"A PLANNED UNIT DEVELOPMENT"
 MDP/ P.U.D. PLAN
 for

The City Staff Development Review Committee has reviewed Woodlake GVH Master Development Plan M.D.P. # 170-A. Please find enclosed a signed copy for your files. Your plan was accepted, however please note the following:

SUBJECT: Woodlake GVH Subdivision Planned Unit Development

SUBJECT: Woodlake GVH, PUD
File #170A/02-010

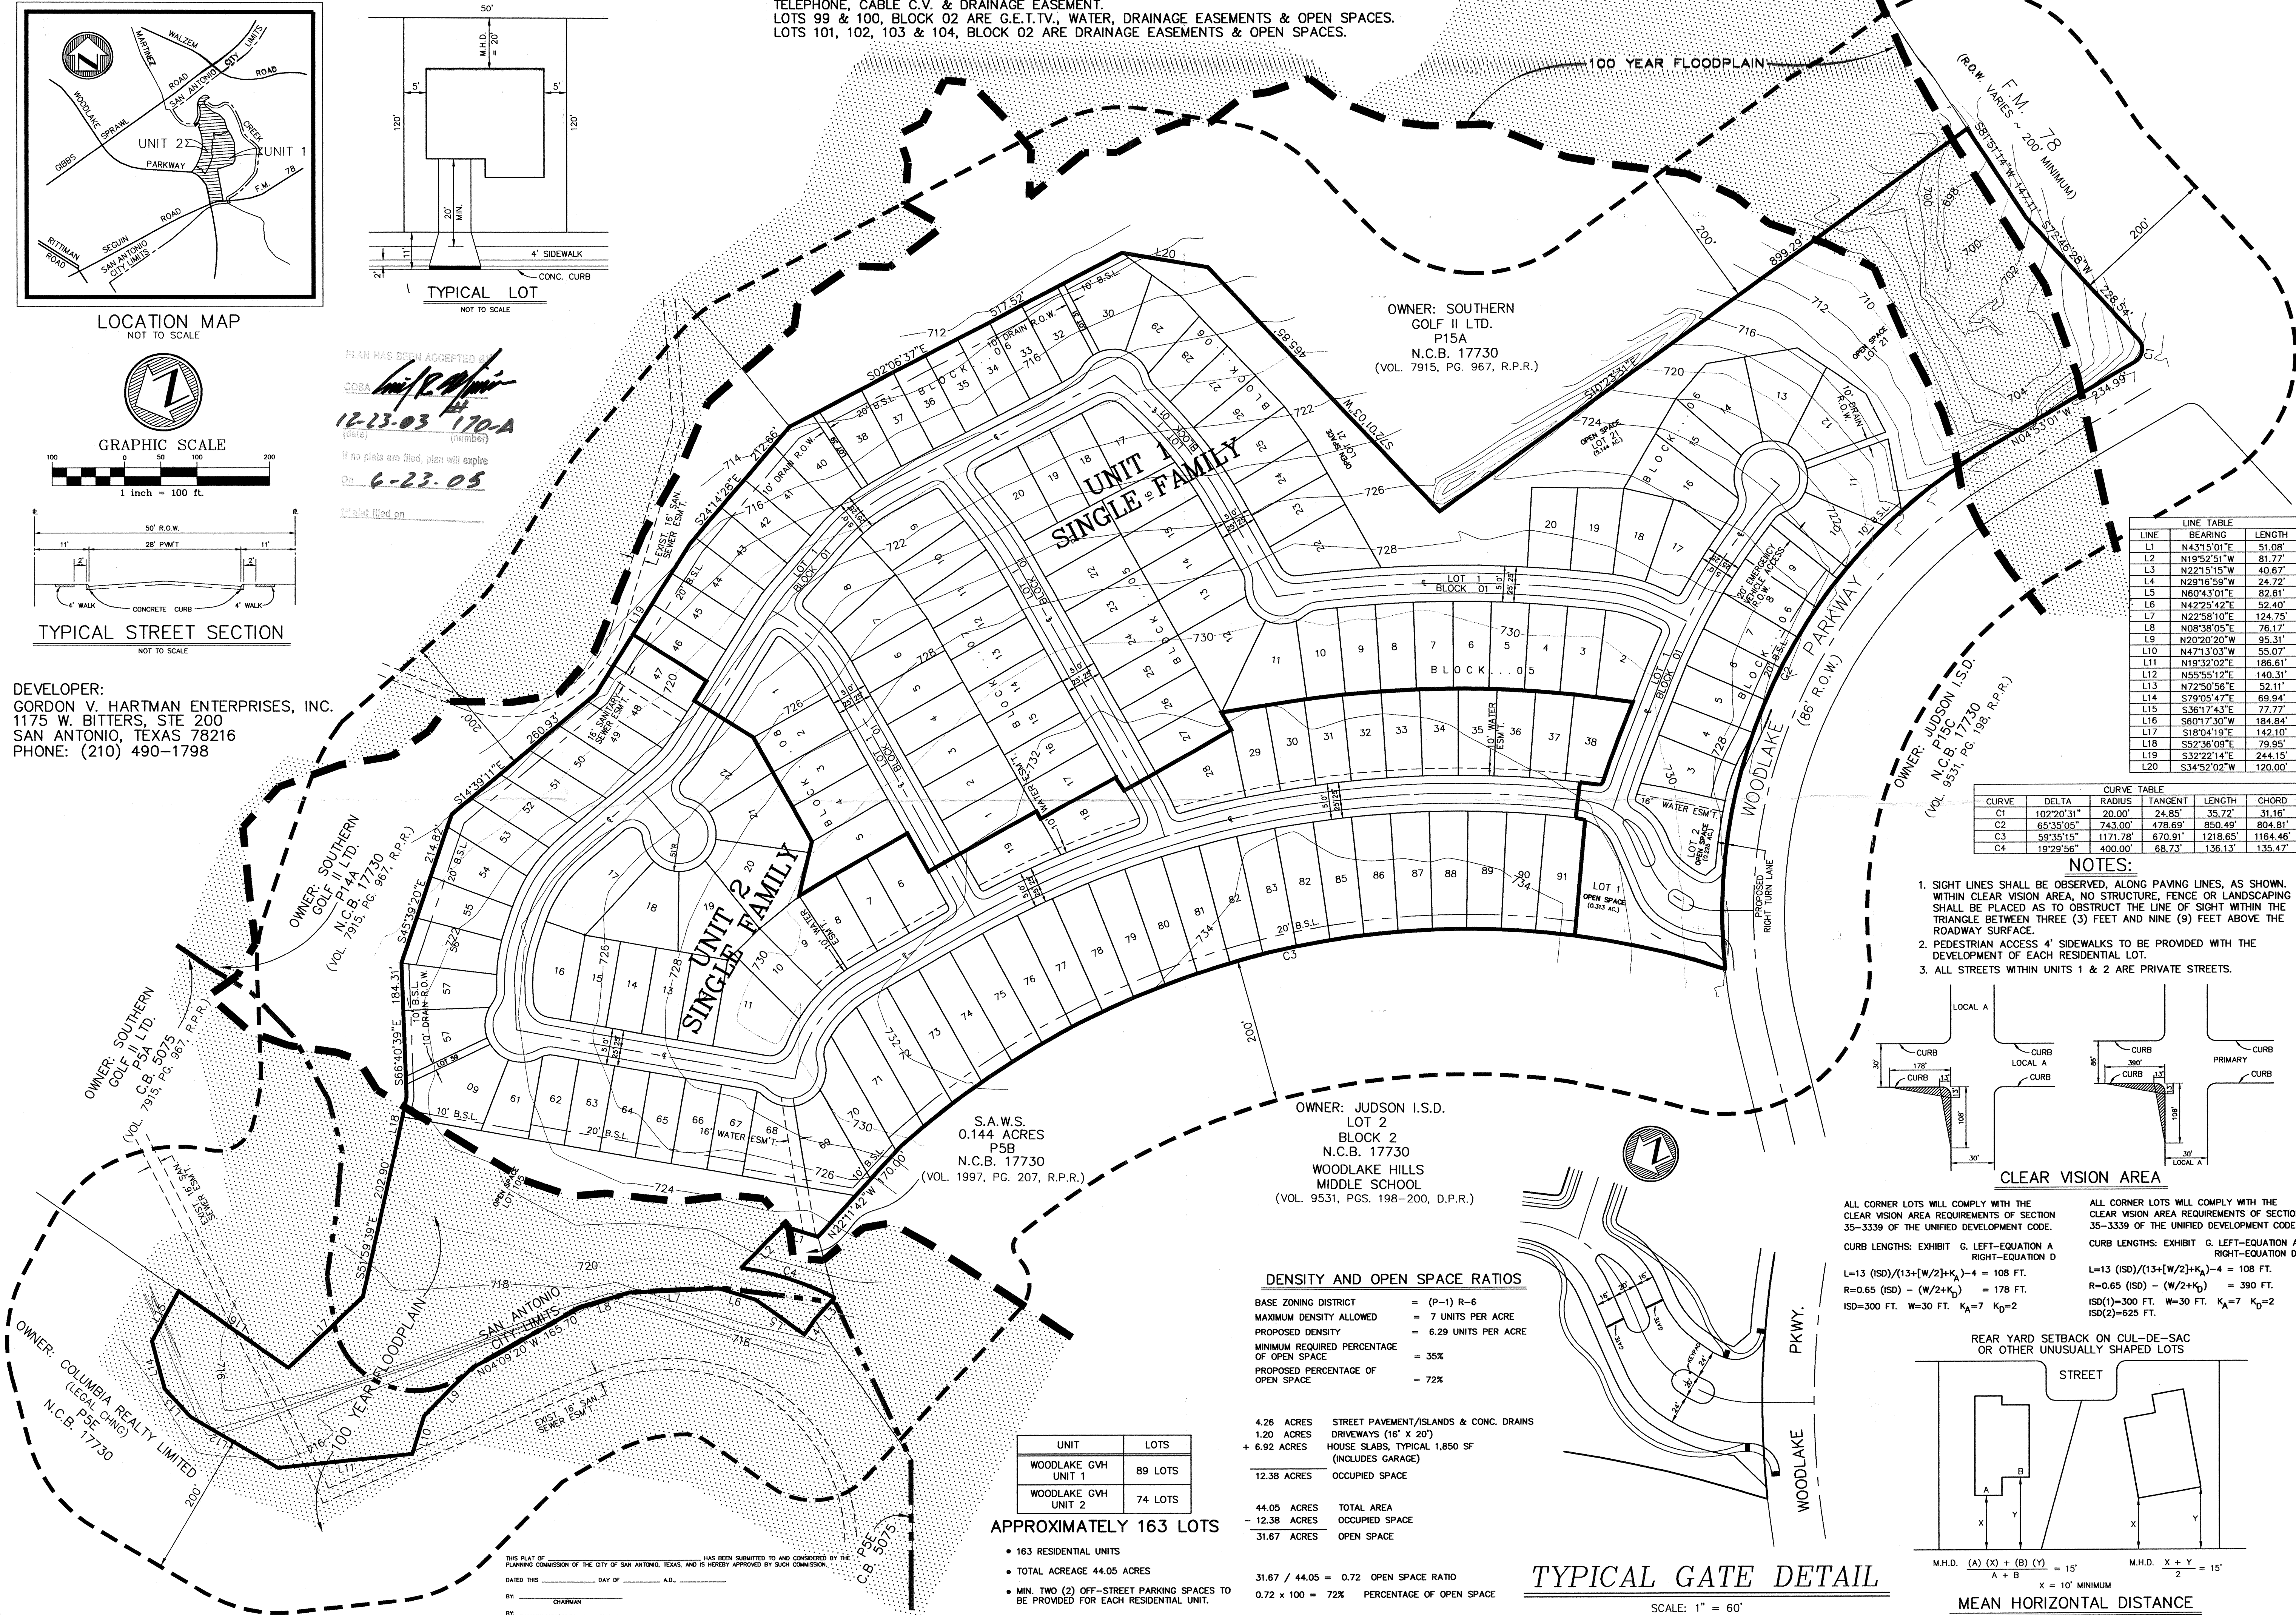
- 1.) DESIGN STORAGE AT ENTRANCE
- 2.) PROVIDE 1' NON ACCESS ESM 'T @ WOODLAKE PRWY.
- 3.) CLEAR VISION - PROBLEM - USE - AASHTO

① Details of emergency
vehicle access shown on
MDP/PUD Plan.

1. The project submittal as discussed in the MDP meeting (June 14, 2002) is considered a new PUD to be reviewed under the new 2001 UDC.
2. Provide a Storm Water Management Plan (section 35-B119) is required per Appendix B, table B-1, H (24), page B-9 of the UDC.
3. The MDP submittal will not be accepted unless a Storm Water Management Plan accompanies the MDP.
4. Preliminary review of the MDP shows that it does not meet the requirement of all weather access to the proposed subdivision.

1. Please review previous comments made June 17, 2002 (attached).
2. A complete Storm Water Management Plan (section 35-B119) is required per Appendix B, table B-1, H (24), page B-9 of the UDC.
3. The most recent submittal on the Woodlake GVH PUD to Storm Water Engineering contains only the flood plain analysis that is only part of a Storm Water Management Plan. Therefore a full review cannot be done until a complete Storm Water Management Plan is submitted.
